F/24/97945 ERECTION OF RETIREMENT LIVING APARTMENTS WITH ASSOCIATED COMMUNAL FACILITIES AND CAR PARKING, THE ERECTION OF A PAIR OF DETACHED DWELLINGS, IMPROVED VEHICULAR ACCESS AND NEW PEDESTRIAN ACCESS TO WINCHESTER ROAD.

LAND AT OAK COTTAGE, WINCHESTER ROAD, BORLEY GREEN, BOTLEY, SO32 2DH

RESPONSE TO LANDSCAPE COMMENTS 9 JANUARY 2025 – SEE BOLD UNDERLINE

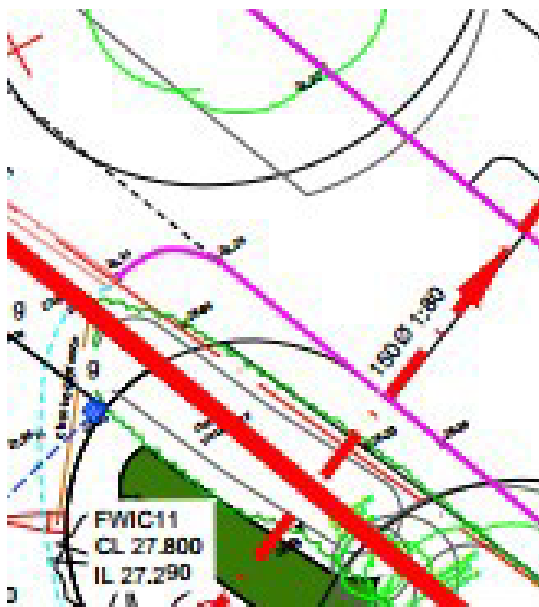
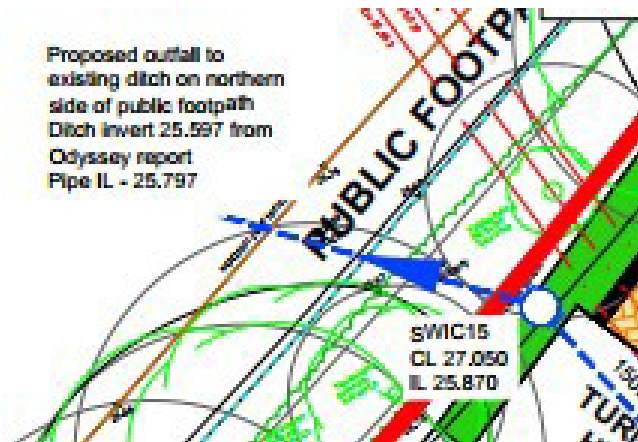
03 Proposal CGI's Winchester Road Frontage and Northern Pedestrian Link- these show neat, clipped hedges (evergreen?). The planting strategy plan indicates all these hedges as native, including thorny species such as Hawthorn and Blackthorn - I suggest that alternative native species such as Hornbeam or Beech hedging are specified.

On the CGI point, it is a CGI and the vegetation is of course "neat". Hedge species around the courtyard and private houses have been changed to hornbeam, leaving the perimeter as mixed native to give a greater diversity and more valuable habitat. (see landscape drawings)

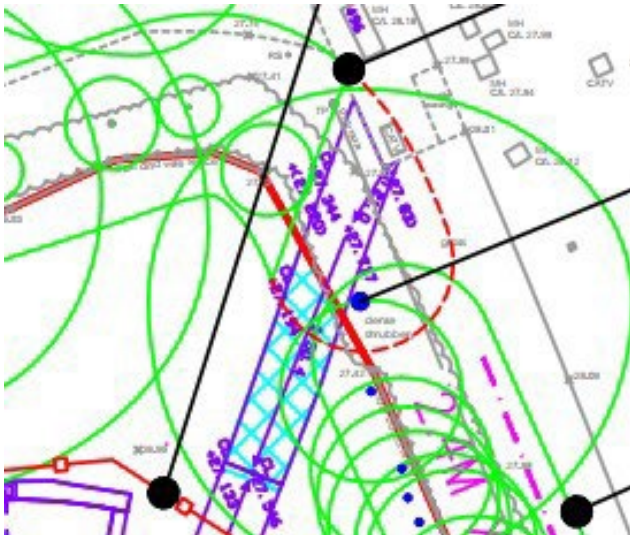
I have 2 areas of concern where installation of proposed SW and FW mains connections may lead to unacceptable loss of vegetation: **Both connection points have moved to limit impact on existing vegetation**

The drainage Engineers and Landscape Architects to liaise to ensure any vegetation loss is reduced to a minimum, and where there is unavoidable loss, it is balanced by new planting.

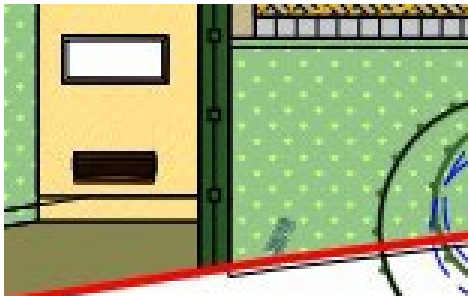
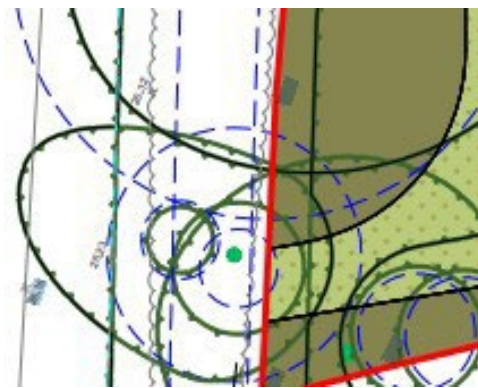
Parking bays 1-3 will lead to potential loss of part of hedgerow T29. This is not acceptable, and the final approved layout must avoid any gaps opening up in the boundary screen along Winchester Road.

The parking spaces coincide with the existing barn and so can be constructed without harm to the hedge – the construction will replace the base of the barn.

The hedge may need to be pruned back and managed by regular trimming but that is what makes a hedge a hedge.

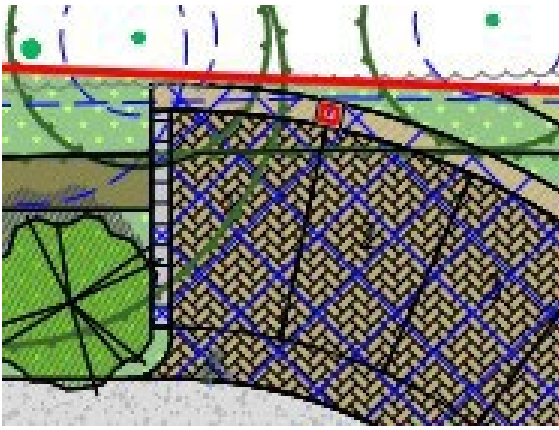
These 4 parking bays may well lead to loss of existing screening and also obstruct any new screen planting - these bays should be omitted or relocated.

The existing hedge will be protected (see arboriculturist's comments above) and will continue to form a decent boundary which will provide connectivity.

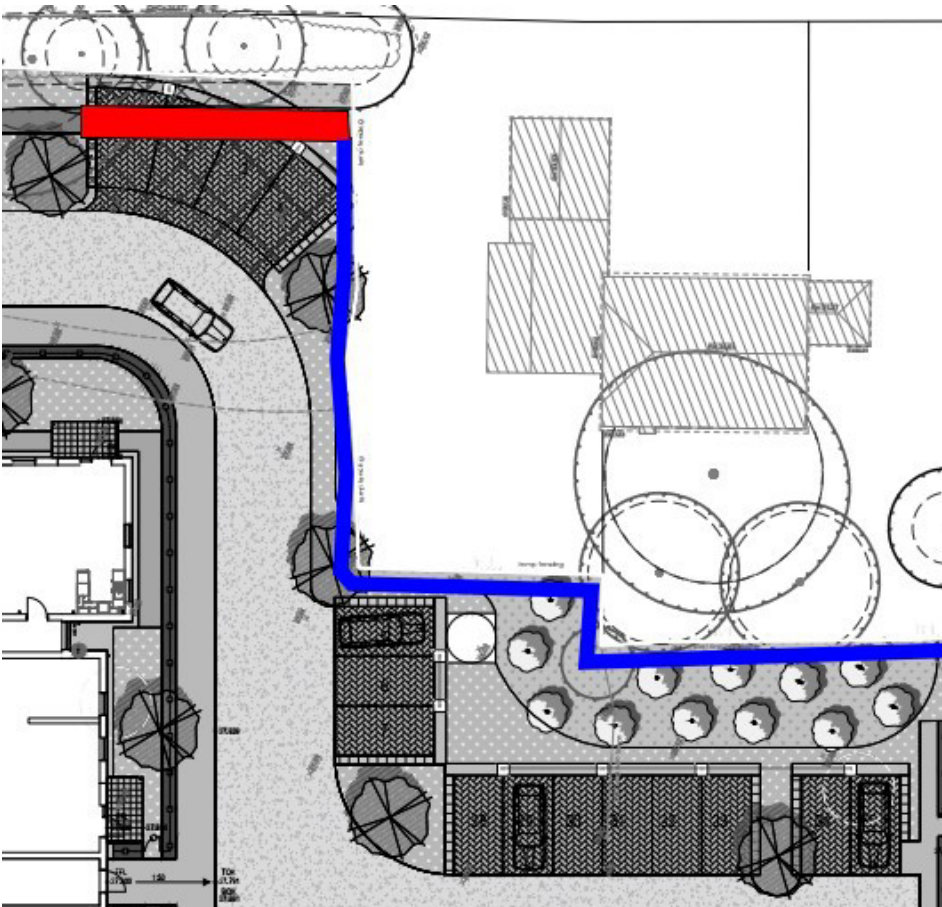
I would prefer to see a native mix hedge running along the SE & S boundaries as per this mark up: **We have added a mixed native hedge as per the blue mark up**

Red = extend boundary screen planting - (around the 4 bays)

Blue = native mix hedge to create new wildlife corridor (along the boundary with the adjoining house) hose and

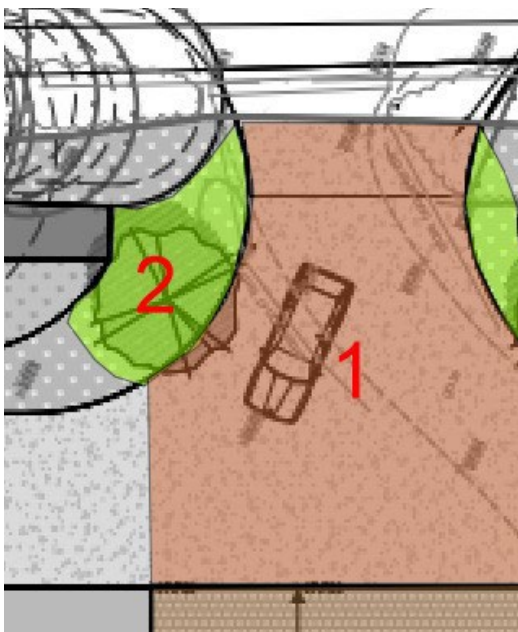
Wildflower grass - in numerous locations these areas have curved/wavy lines. How will these be indicated on the ground to help the landscape maintenance crew locate the boundary between mown and wildflower grass? There are some thin and isolated areas of wildflower grass that should be omitted as they will be hard to maintain. **The wavy lines are indicative and not critical but once established (by referring to the plans) the appearance of the 2 types of grass will be different and they can use this as a guide to follow.**

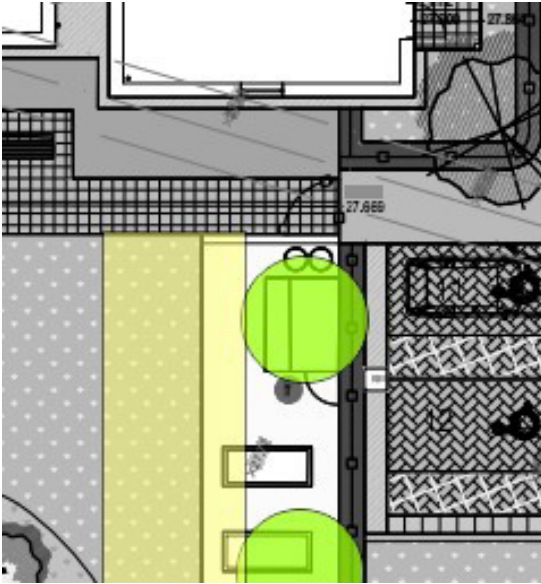
The main entrance is a key area along the identified central vista. I suggest this zone is given an uplift similar to the markup below: **We have amended the drawing to add planting flanking the entrance and added block paving. A planting bed has been added to the front entrance.**

1 = area of contrasting block paving to mark arrivals and slow traffic

2 = low shrubs and groundcover to frame drive

3 = further design work to provide this key area of paving with added interest

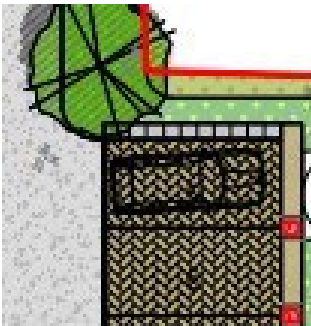
Please clarify what this white square/inner circle represents? We have added to the key – this is an access cover to the pumping plant
